**DEPARTMENT OF PLANNING
AND ZONING STAFF REPORT**

Date of Hearing: May 19, 2015

SUBJECT: CMPT-2015-0002, Loudoun County School Board,
The Academies of Loudoun

Figure 1. Existing Conditions and Potential Building Areas.

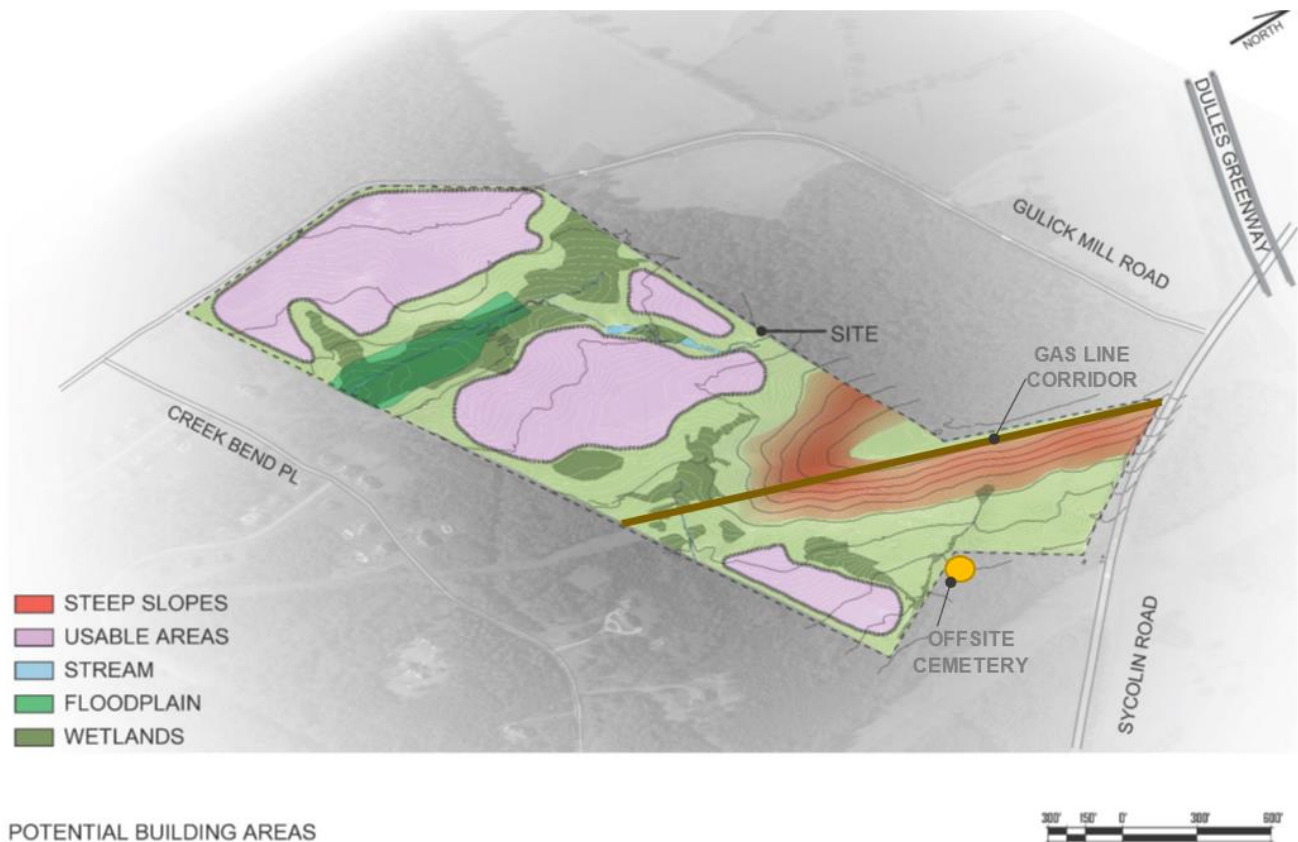
The subject property contains environmentally sensitive areas with approximately 5.50 acres of minor floodplain within the FOD (Floodplain Overlay District), 4,043 linear feet of streams, and 16.58 acres of wetlands. There are no major flood plain areas on the property. There are approximately 6.25 acres of moderately steep slopes and 1.28 acres of very steep slopes. The subject property drains to the south towards unnamed tributaries to the Goose Creek and is located within the Lower Goose Creek watershed. Other existing site features include remnants of stone walls that extend along portions of the western, southern, and eastern property boundaries. There are no existing wells or drainfields. Along the northern portion of the subject property, 6.27 acres is within the AI (Airport Impact Overlay) District within one mile of the LDN 60 contour of the Leesburg Executive Airport.
